Access Compliance Report

Public Rights-of-Way

(Curb Ramps)

Intersection ID: 43737	Main Street: ASHLYN_CHASE_CT	Cross Street: BRIDGEVIEW_LN	Location: NE
ADA ID: 0AD138ED9781	Ramp Type: PerpDiag	Initial Pass/Fail: Fail	Overall Compliance: No
		Severity Score: 42.5

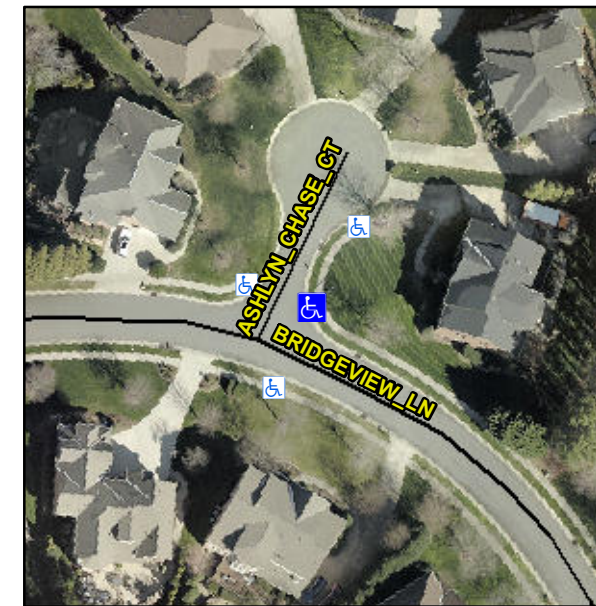
Not Found, R304.5.1, R304.2.2, R304.5.3

Compliance	Description	Data	Compliance	Description	Data
N/A	Ramp Length (in)	50.0	No	Ramp Slope (%)	8.6
No	Ramp Width (in)	35.0	No	Ramp XSlope (%)	5.1
N/A	Flare Type LT	N/A	N/A	Flare Type RT	N/A
N/A	Flare Slope LT (%)	N/A	N/A	Flare Slope RT (%)	N/A
N/A	Flare Traversable LT?	N/A	N/A	Flare Traversable RT?	N/A
N/A	Landing Length (in)	N/A	N/A	DWS Provided?	N/A
N/A	Landing Width (in)	N/A	N/A	DWS Contrast?	N/A
N/A	Landing Slope (%)	N/A	N/A	DWS Length (in)	N/A
N/A	Landing X Slope (%)	N/A	N/A	DWS Full Width?	N/A
N/A	Landing Curb? (Y/N)	N/A	N/A	DWS Offset (in)	N/A
N/A	Shared Landing?	N/A			
N/A	Gutter Ponding?	N/A	N/A	Gutter Slope (%)	N/A
N/A	Gutter Lip Ht (in)	N/A	N/A	Gutter X Slope (%)	N/A
N/A	Painted X Walk1?	No	N/A	Painted X Walk2?	No
	X Walk 1 Direction	To NW		X Walk 2 Direction	To SW
N/A	X Walk 1 Width (in)	N/A	N/A	X Walk 2 Width (in)	N/A
	X Walk 1 Slope (%)	4.7		X Walk 2 Slope (%)	1.0
	X Walk 1 X Slope (%)	1.8		X Walk 2 X Slope (%)	5.5

Remove & Replace Curb Ramp With Two New Directional Ramps or Equivalent.
